SERVICE BULLETIN

ENGINE - DIFFUSER AND COMBUSTION GROUP AND NO.4 BEARING FRONT AND REAR COMPARTMENT -
INCORPORATE NEW NO. 4 BEARING CARBON SEAL ASSEMBLIES MADE OF REVISED MATERIAL -
CATEGORY CODE 6 - MOD.ENG-72-0032

V2500-ENG-72-0032

Location and Modification of the No.4 Bearing Front Seal Assembly (2A2055)
Fig.1

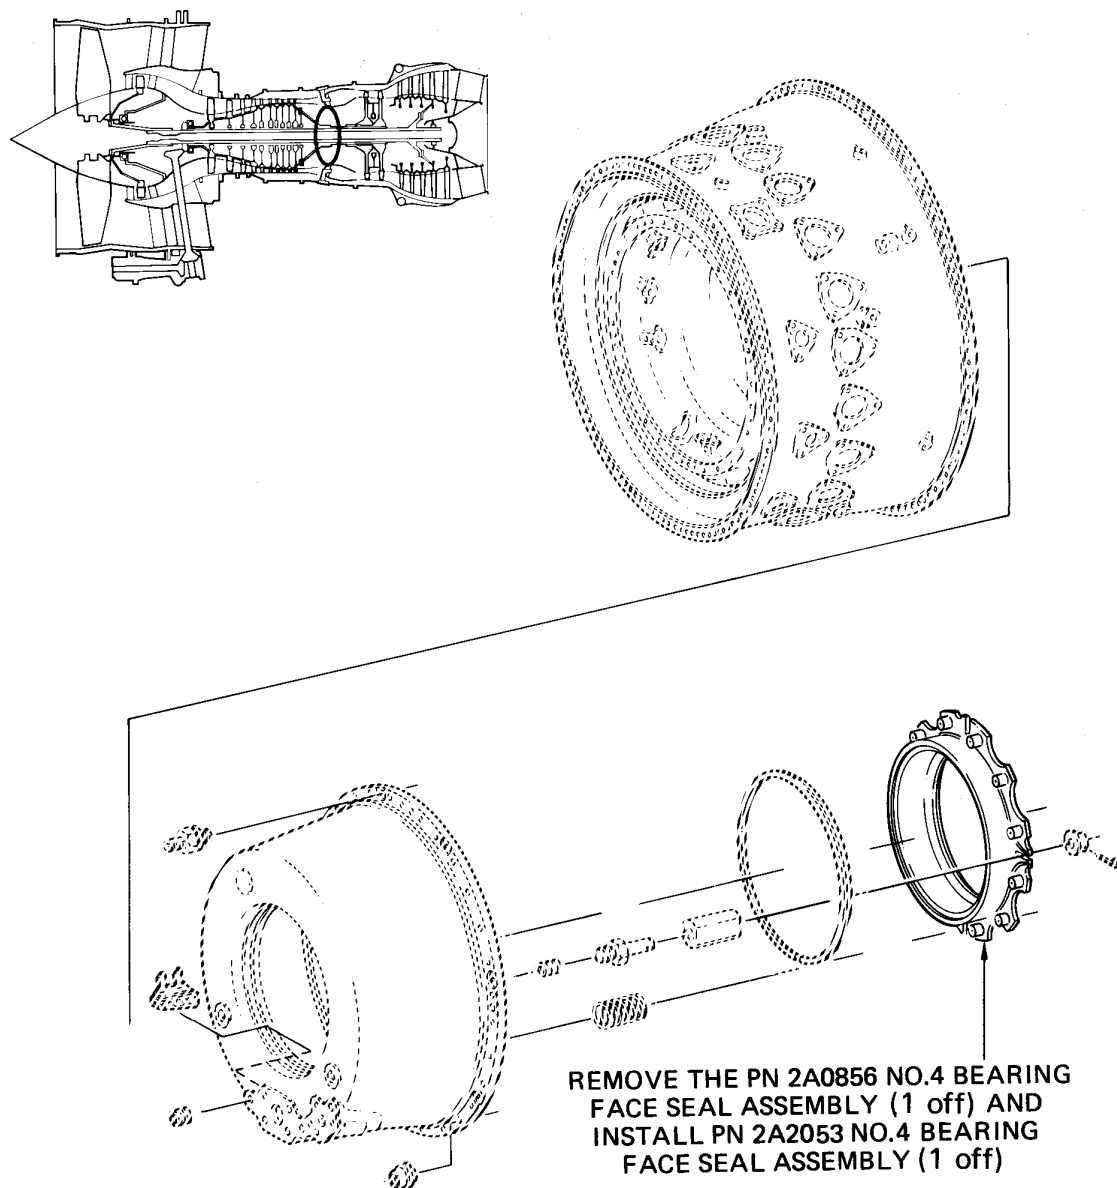
- (1) Install the 2A2053 No.4 Bearing Face Seal Assembly (1 off) in the Front Seal Assembly by the approved procedure in Reference (2), Chapter/Section 72-42-33, Assembly. See Figure 1.
- (2) Identify the new No.4 Bearing Front Seal Assembly as 2A2055 by the approved procedure in reference (3), Chapter/Section 70-09-00, Marking of Parts. Use the vibration peen method.
- (3) Install the 2A2053 No.4 Bearing Face seal Assembly (1 off) in the Rear Seal Assembly by the approved procedure in Reference (2), Chapter/Section 72-43-20, Assembly. See Figure 2.
- (4) Identify the new No.4 Bearing Rear Seal Assembly as 2A2056 by the approved procedure in Reference (3), Chapter/Section 70-09-00, Marking of Parts. Use the vibration peen method.

Location and Modification of the No.4 Bearing Rear Seal Assembly (2A2056)
Fig.2

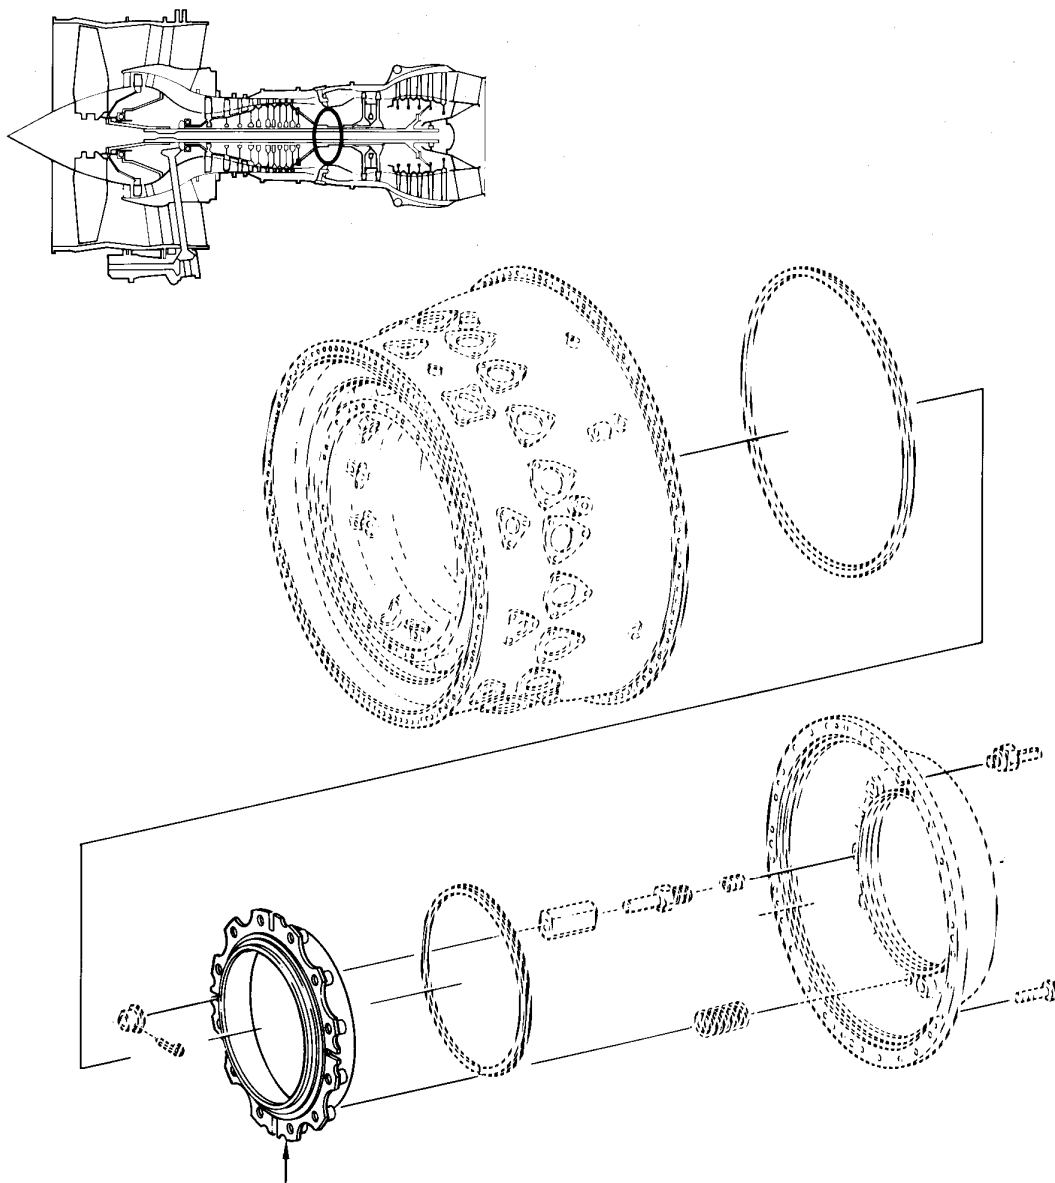
REMOVE THE PN 2A0856 NO.4 BEARING
FACE SEAL ASSEMBLY (1 OFF) AND
INSTALL PN 2A2053 NO.4 BEARING
FACE SEAL ASSEMBLY (1 OFF)
